2ND ADDENDUM AND RESPONSE TO RFI FOR DA/251/2013/A, DA/1188/2017 AND DA/1191/2017

20 PACIFIC HIGHWAY, BENNETTS GREEN

ADDENDUM AND RESPONSE TO RFI FOR DA/251/2013/A, DA/1188/2017 AND DA/1191/2017 – 20 PACIFIC HIGHWAY BENNETTS GREEN

Figure 2 – Revised Site Layout (for Approval)

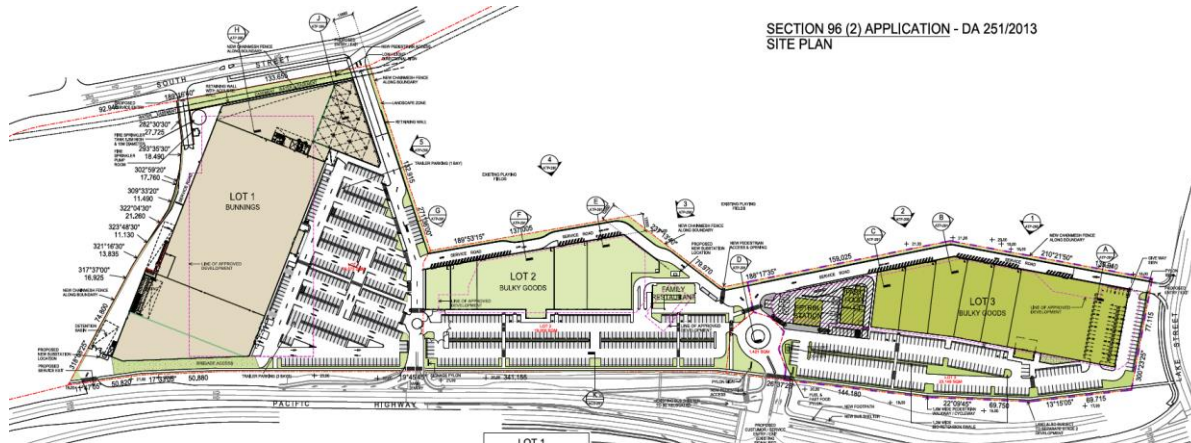
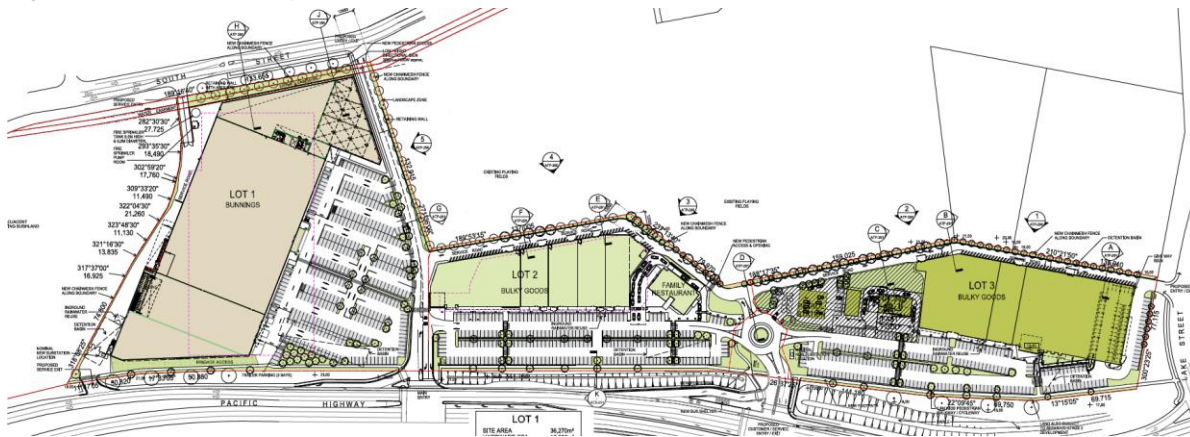
The applicant has worked closely with Council and key authorities including RMS to resolve a wide range of issues raised in the RFI. In resolving these matters, various amendments were made to the site layout which are summarised below and represented illustratively in Figure 1 and Figure 2:

- Both Pacific Highway intersections have been amended, including further internalising the Groves Road roundabout within the site.
- Access to the site from the Pacific Highway intersections has been updated.
 - The right turn exit from the site onto Pacific Highway at Groves Road has been removed.
 - A right turn exit onto Pacific Highway at the southern intersection has been added; and
 - South roundabout replaced with offset T-intersections.
- In response to Council comments, the service road has been updated to be one-way southbound.

- The Restaurant tenancy in Lot 2 has been reorientated 45 degrees and incorporates a revised drive-through design.
- The previously interconnected Petrol Station and Fast Food building in D/1188/2017 has been separated into two buildings.
- The amendment to the Petrol Station and Fast Food layout has required adjustment to the Lot 3 bulky goods building footprint.
- The eastern façade of the Lot 3 bulky goods footprint has been further resolved due to design development.
- The location of the Lot 2 building entry (Anaconda) has been relocated, resulting east façade change.

Figure 8 – Signage Details

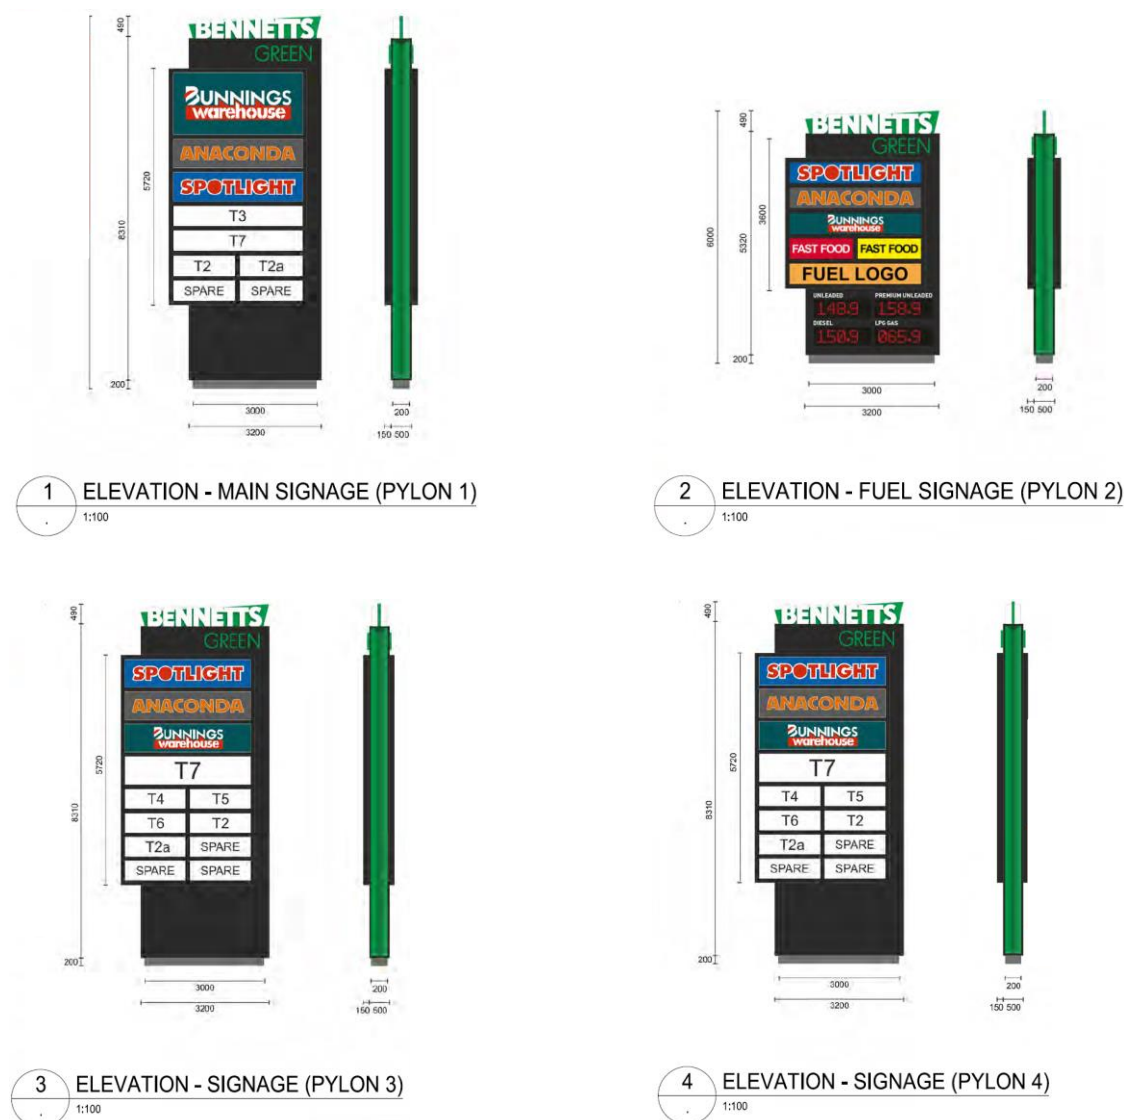
In response to Council's May 2018 RFI, the scheme has now been amended to include:

- 2 x 9m Pylon signs on Pacific Highway.
- 1 x 9m Pylon sign at the Lake Street entry.
- 1 x 6m sign - relocated within the boundaries of the service station; and
- 1 x ~3m entry sign at South Street.
